Amendment to the Drawings

09/974,747

FIG. 5

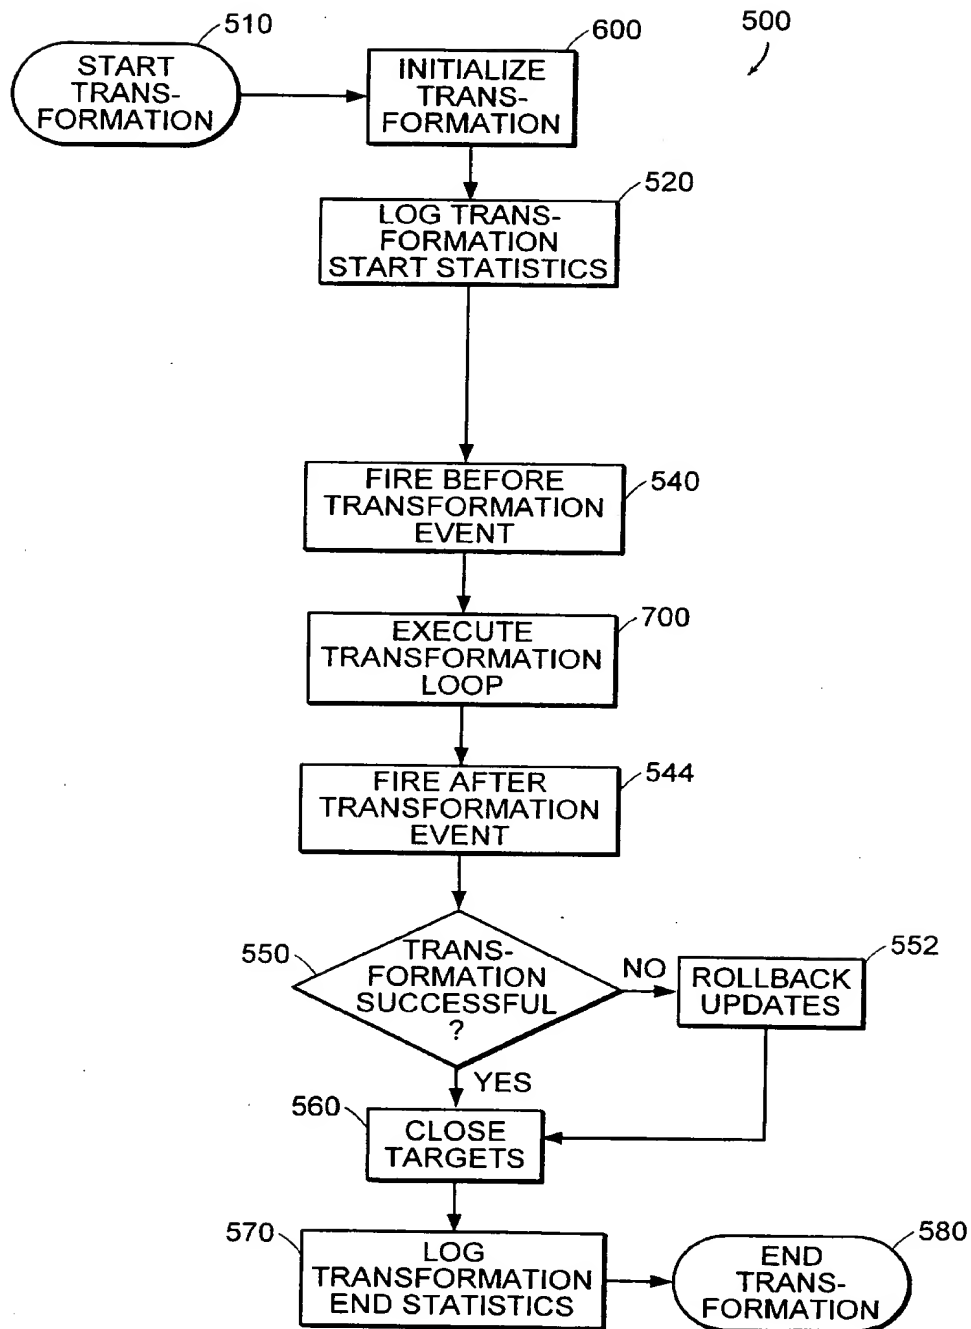
Attached are formal drawings (8 sheets) of Figs. 1-8. The drawings include a change to Fig. 5 to correct a typographical error in block 544. In particular, the word "AfterConversion" has been changed to "AfterTransformation." Support for such a change may be found, for example, on page 49, lines 27-28, of the specification. The amendment to Fig. 5 is submitted for clarification purposes only and does not present new matter. Approval of the submitted changes by the Examiner is requested.
